# PLAN OF PROPOSED IMPROVEMENT

## 252 DUNNING ST

CITY PROJECT NO. 14524  
CONTRACT NO. 9278

REVISION 1 - 09/09/24  
- UPDATED SHEETS: U1, U3-U4

14524	14524	14524	U-1
MADISON, WI	9278	U-1	U-1
CONTRACT NO:	9278	U-1	U-1
SEWER PLAN & PROFILE - LINDEN AVE	252 DUNNING ST	14524	U-1

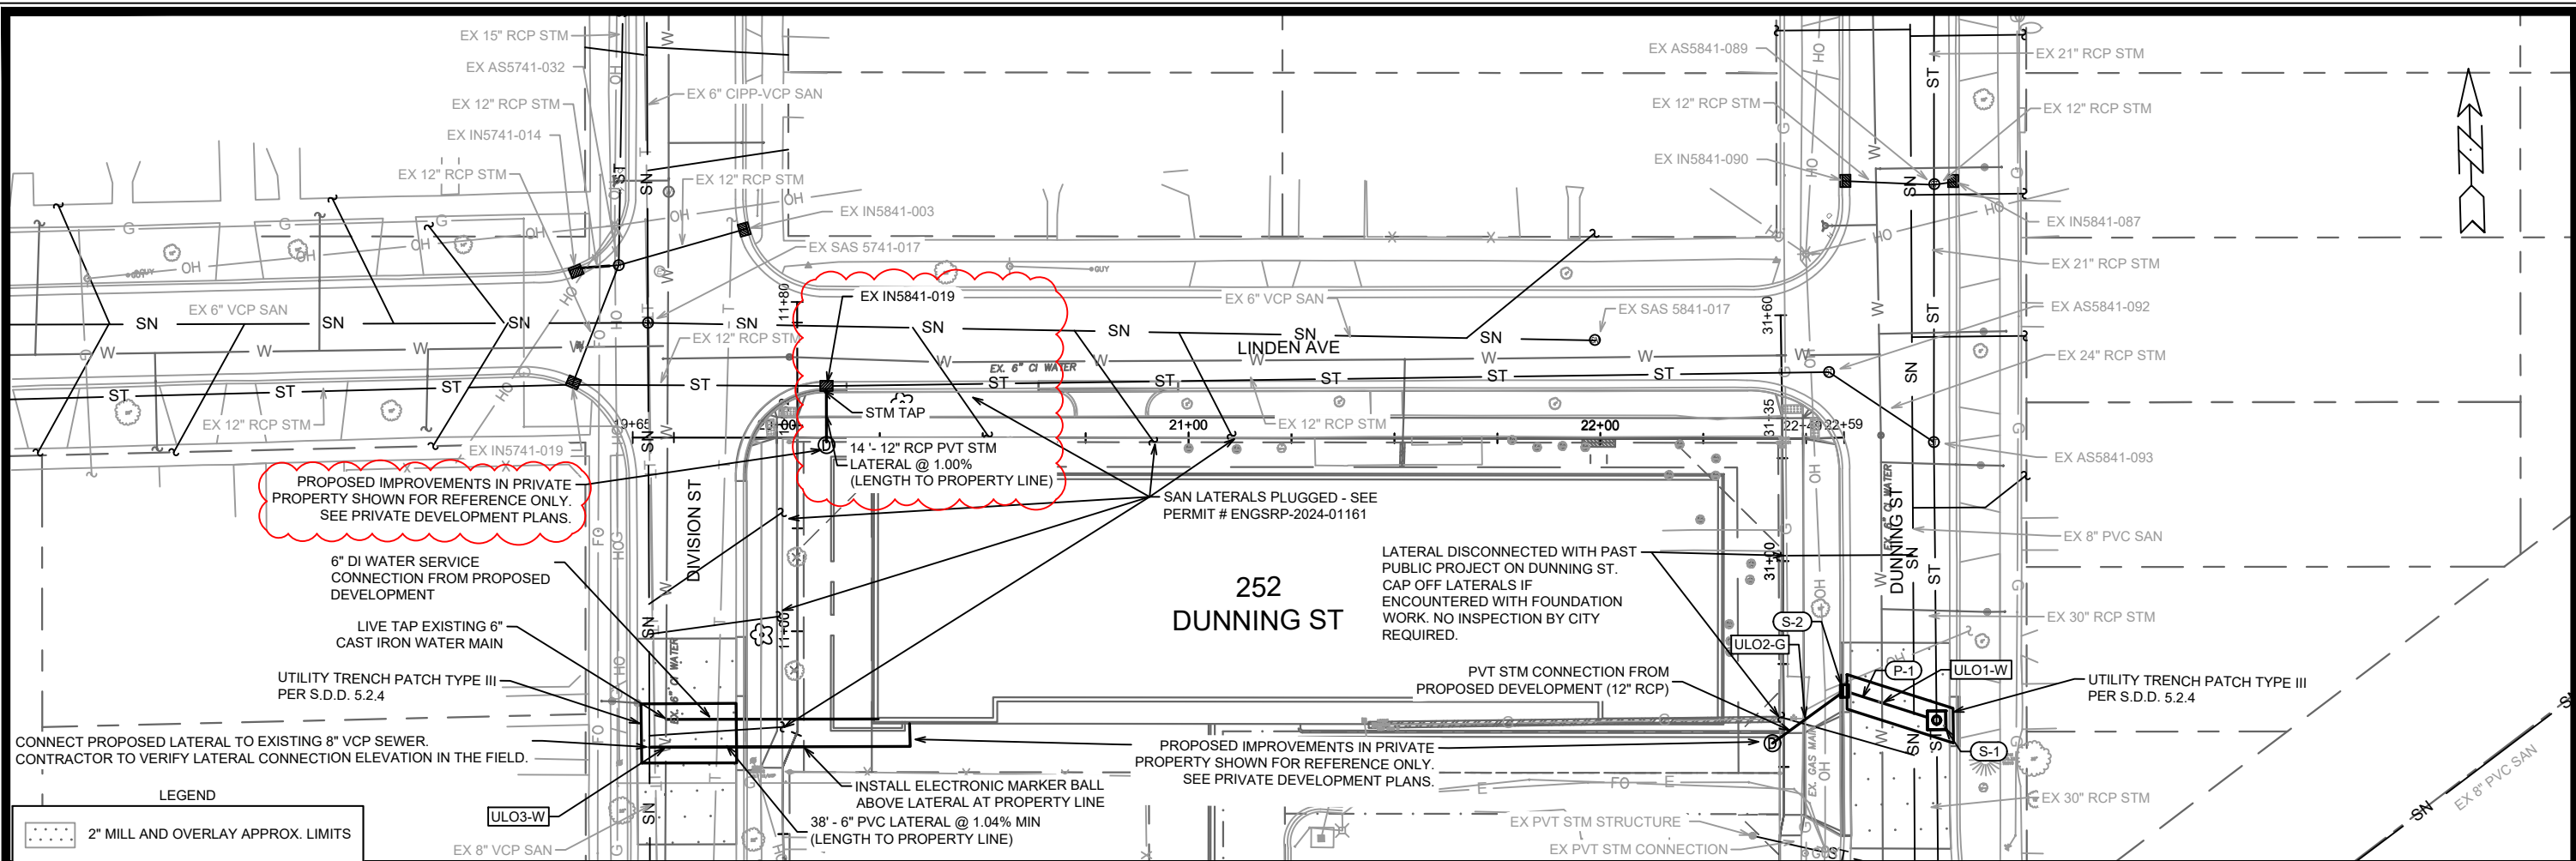
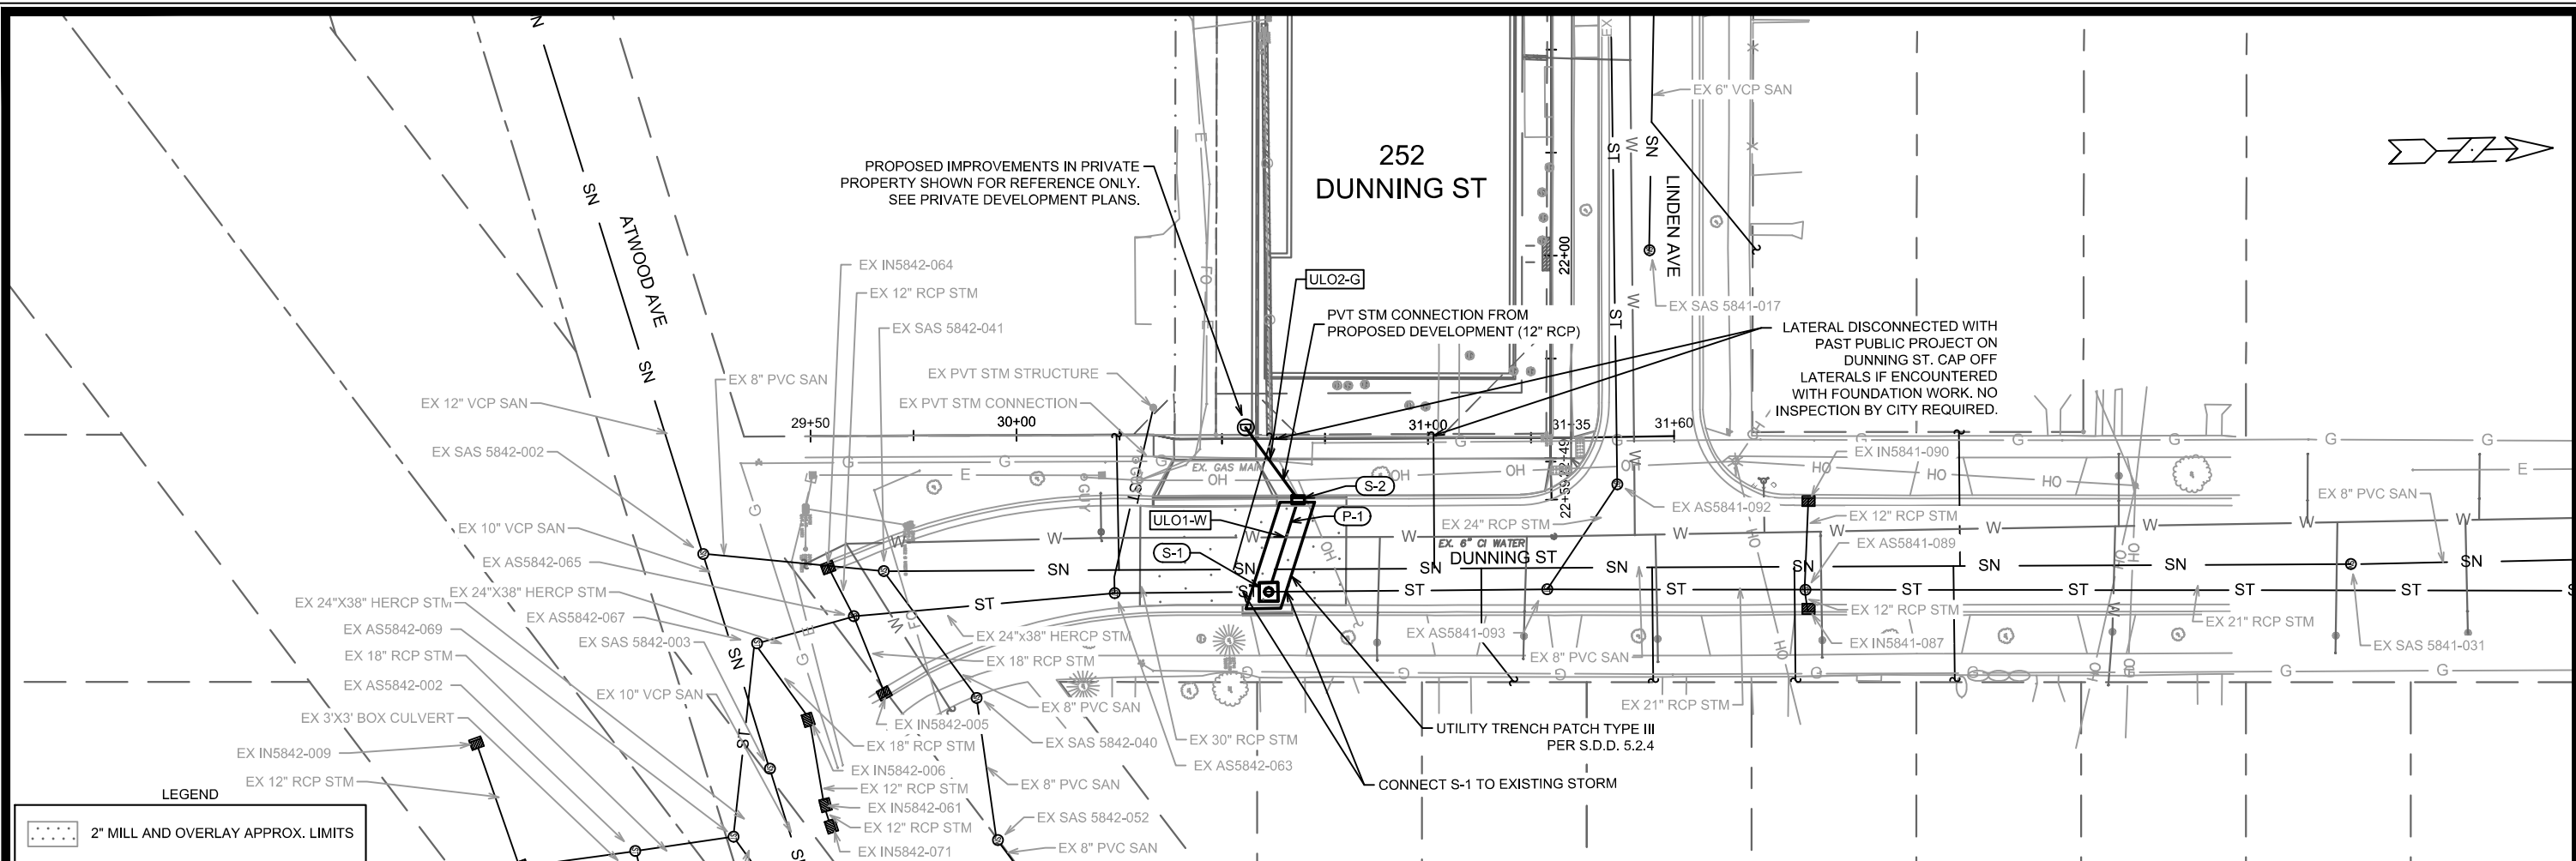
**REVISION #1: 9/9/2024**

1. STORM TAP AND PRIVATE STORM LATERAL INTO IN5841-019 ADDED TO PUBLIC PLAN

14524	U-3
IN5841-019 STORM TAP AND LATERAL	DATE: 9/9/24
REVISION	BY
MARK	Scale: #####
Designed By: ##	Date: 9/9/2024 1:48 PM
14524	U-3

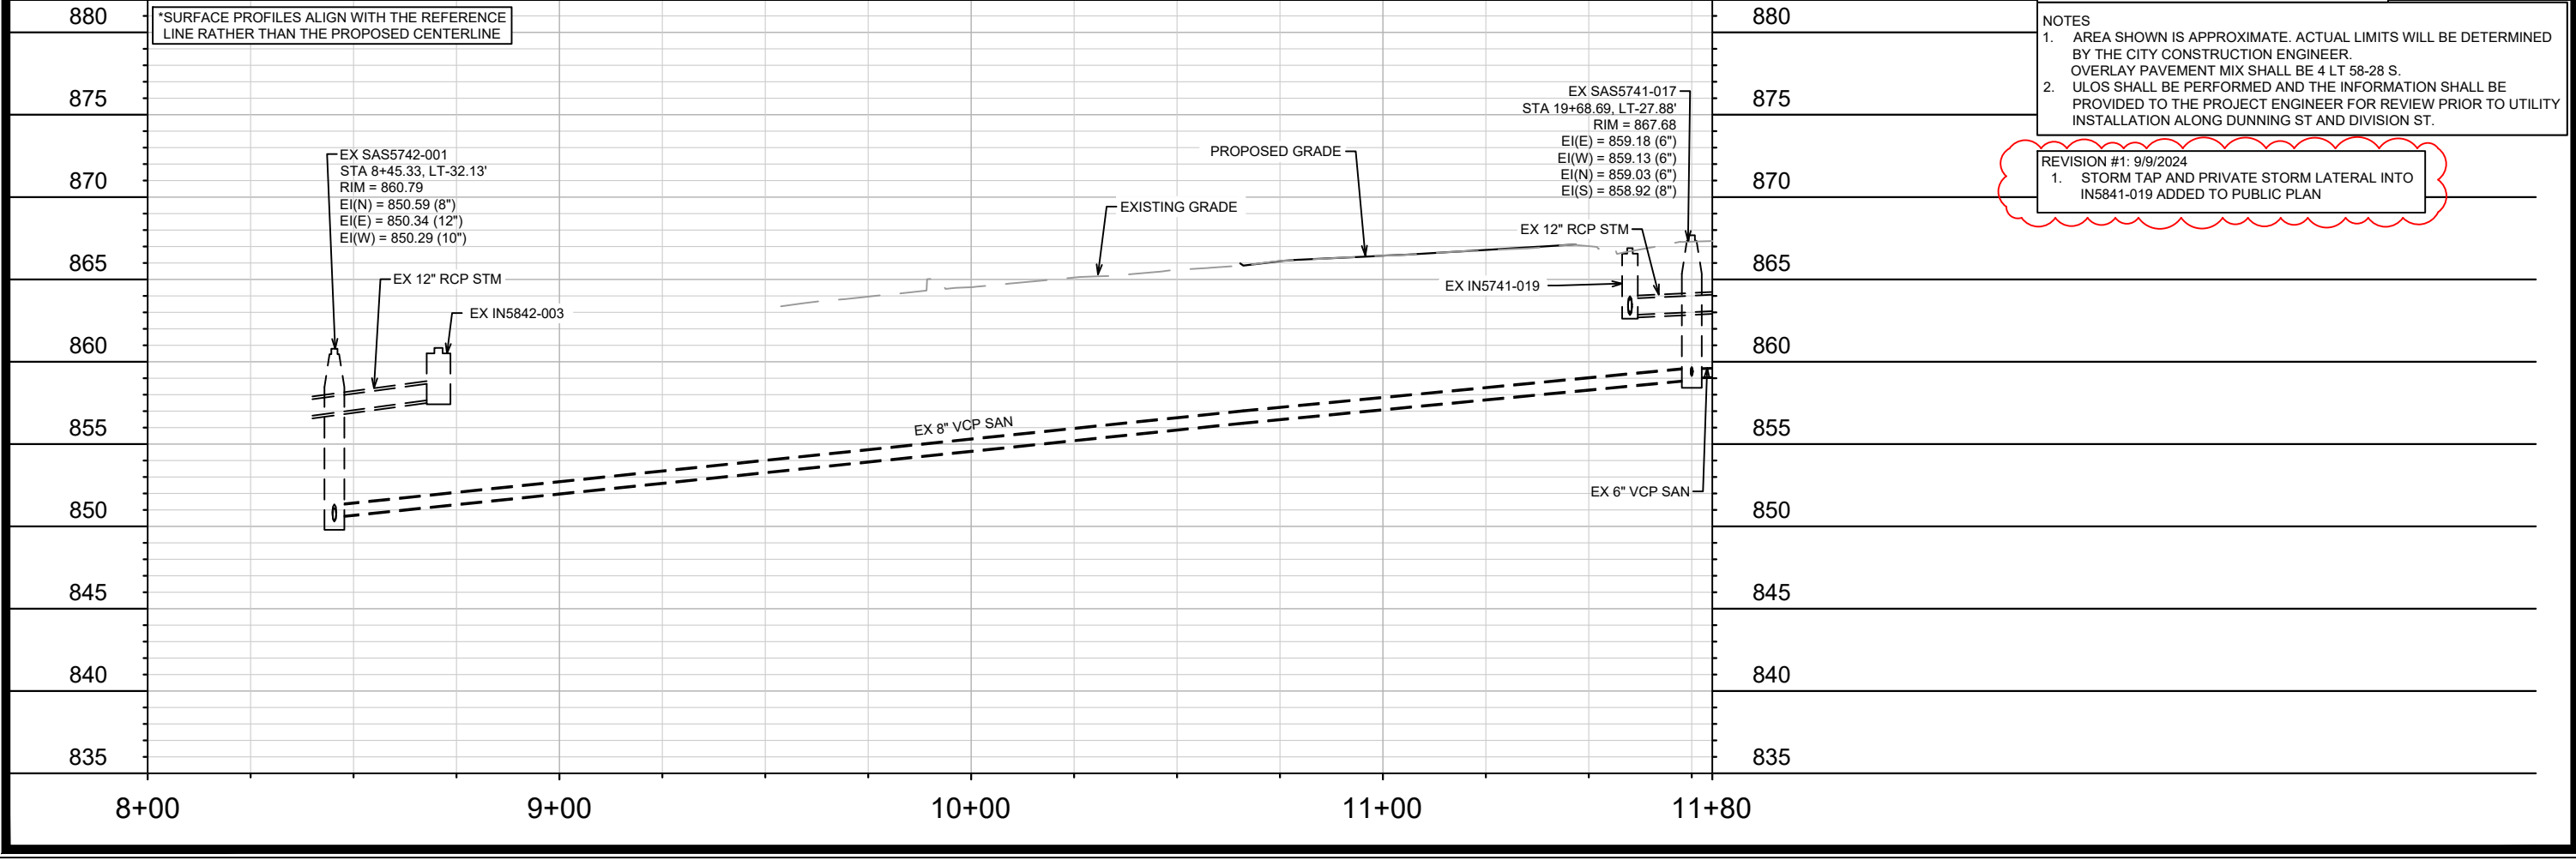
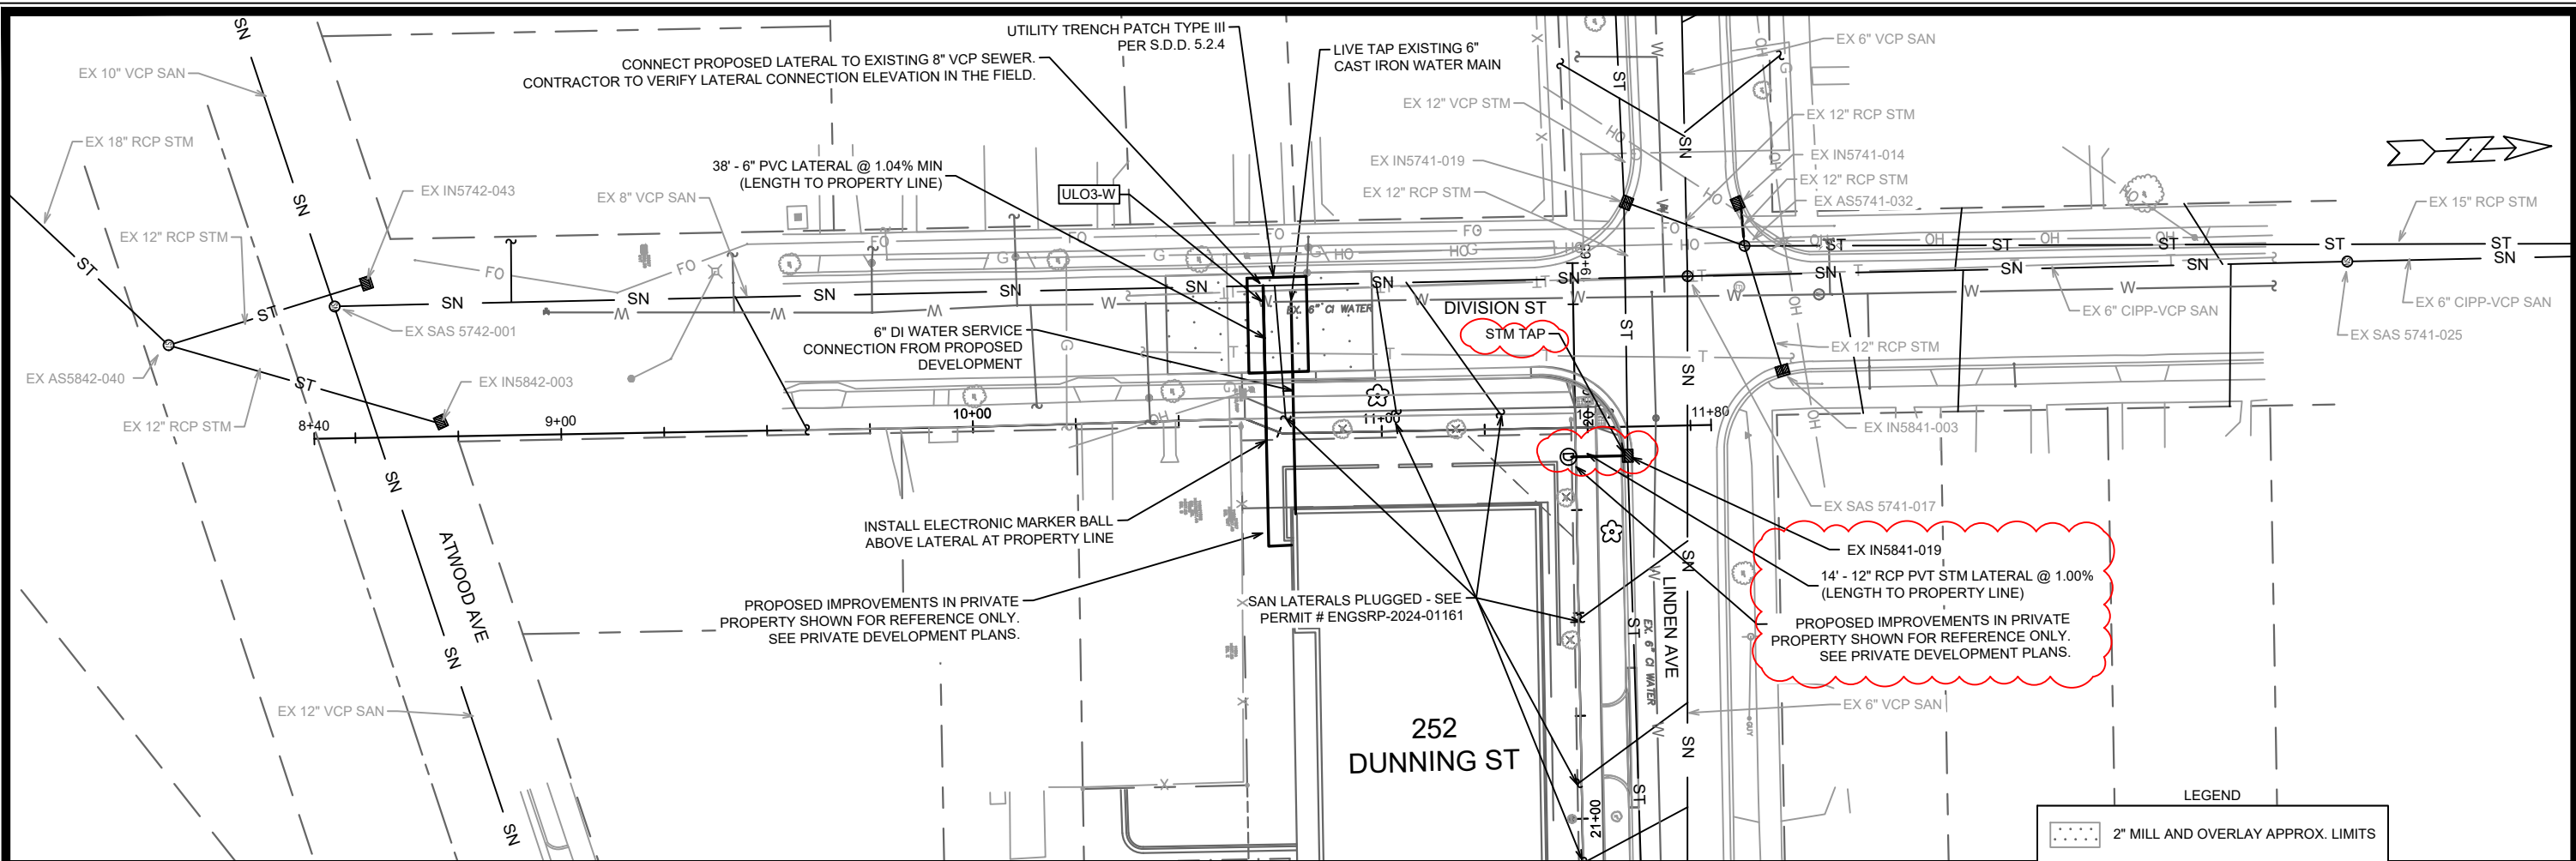
REVISION #1: 9/9/2024  
 1. STORM TAP AND PRIVATE STORM LATERAL INTO IN5841-019 ADDED TO PUBLIC PLAN
